Proposed Large-scale Residential Development (LRD) in the townlands of Bohernabreena, Oldcourt & Killinenny, Dublin 24.

**Statement of Response to South Dublin County Council
LRD Opinion Ref. LRDOP001/24.**

DATE: September 2024.

Fig. 1 – Proposed Hedgerow Retention and Removal

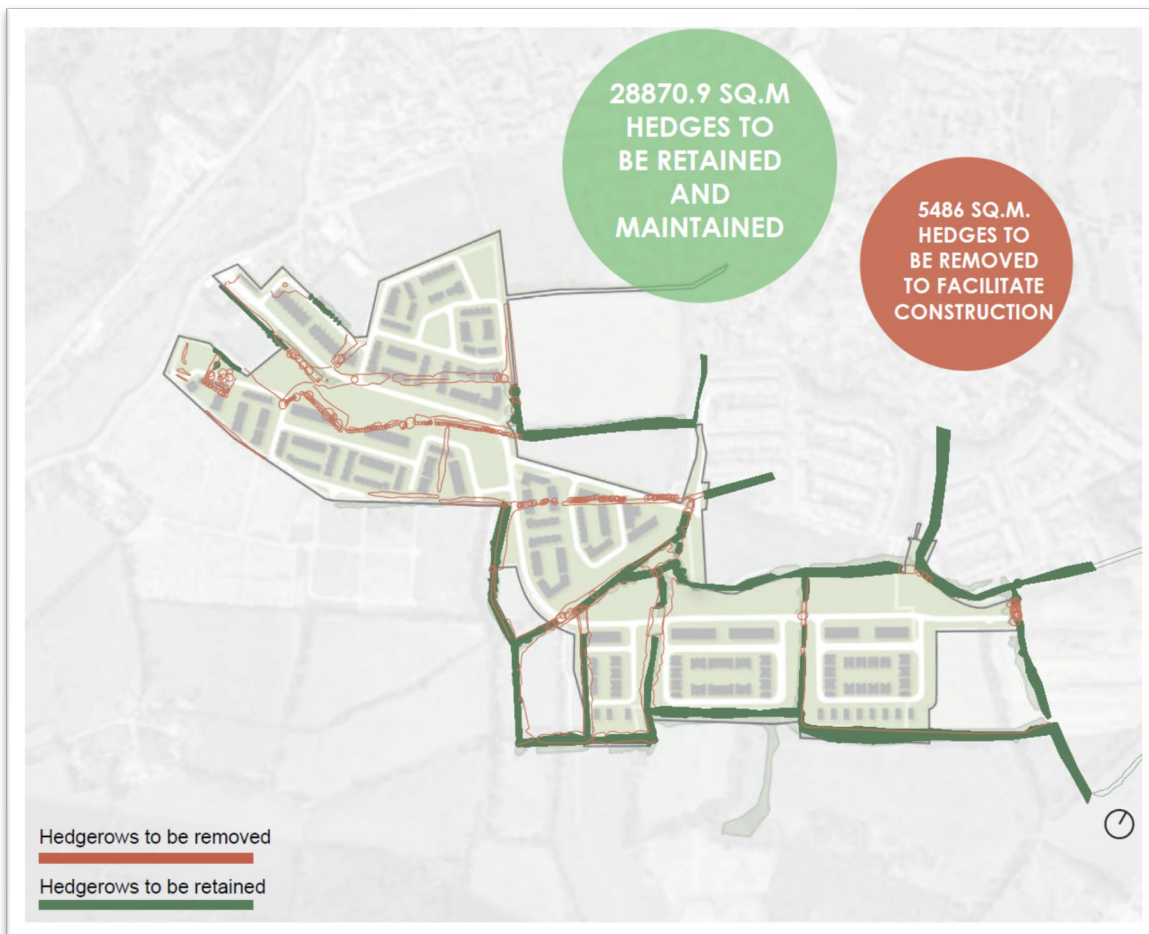
Reduction in the fragmentation of hedgerow by ensuring all hedgerow is maintained in public open space areas and reconfiguration of pathways to minimise impacts to existing hedgerow. Revision to design of Oldcourt Park to minimise impacts to existing hedgerow. Hedgerow should not be provided in any private open space areas and should not form the site boundary of any single dwelling.

Hedgerows are to be retained to the greatest extent possible, with removal considered only where necessary for the implementation of larger connecting structures, such as the proposed east-west main link street, which is a Development Plan and Local Area Plan objective.

As confirmed in the submitted Landscape Design Rationale, approximately 28,870.9sq.m of hedges are to be retained and maintained as part of the proposed development. These have been incorporated into the proposed landscape design with appropriate buffers around same provided for.

Fig. 4 – Proposed Connectivity

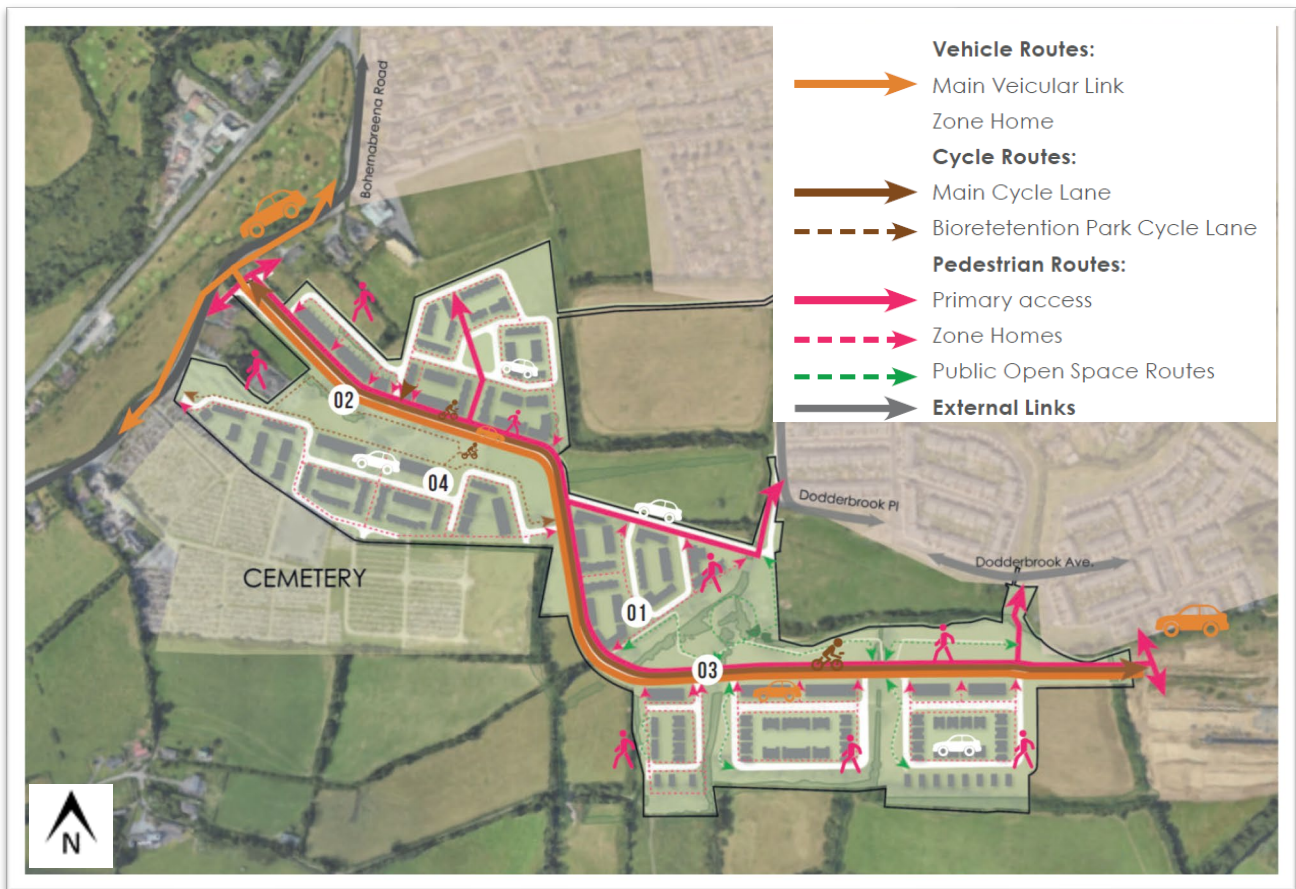
Additional connections to adjoining lands should be sought, in particular pedestrian and cycle links and an additional route through 'OS' lands connecting to Ely View. Details of all connections should be provided, to confirm connectivity of all routes and a permeability map should be submitted.

From this main route, various secondary routes have been designed and integrated for both vehicles and pedestrians/cyclists. This creates a comprehensive network of access, facilitating movement and interaction between different areas of the proposed development. Moreover, connectivity goes beyond logistical efficiency; it extends to the user experience. Thoughtfully planned pathways, coupled with well-designed elements, intuitively guide visitors, fostering an accessible, enjoyable, and harmonious experience throughout the space.

Vehicular access from the proposed development into Dodderbrook to the north, at Dodderbrook Place is proposed. In addition, pedestrian and cyclist access only is catered for into Dodderbrook Avenue. The proposed east – west main link street includes dedicated pedestrian and cyclist paths thus affording ease of access throughout the entire scheme and onwards to Oldcourt Road and Bohernabreena Road and beyond. In Neighbourhood Zone 3 to the north, a pedestrian / cyclist access point into St. Anne’s GAA Club is afforded, to be delivered in a agreement with the GAA Club. Figure 4 illustrates the permeability map, a larger version of same is enclosed in the Landscape Design Rationale prepared by Gannon & Associates, Landscape Architects (refer to 6.3.1, page 69).

The red line of application (save for the facilitation of a proposed sewer) does not provide for development near or abutting Ely View, and therefore connections into same are not proposed as part of this current development proposal. However, as per section 7.5 of the enclosed Planning Statement which addresses the overhead ESB power lines and the possible future development options for same, and as per the submitted Davey+Smith drawing no. MP17, which illustrates the proposed LRD, alongside potential future development on the applicant’s adjoining lands should the overhead wires be relocated southwards, should this occur in the future, an application for permission for could accommodate *pedestrian and cycle links to Ely View*.
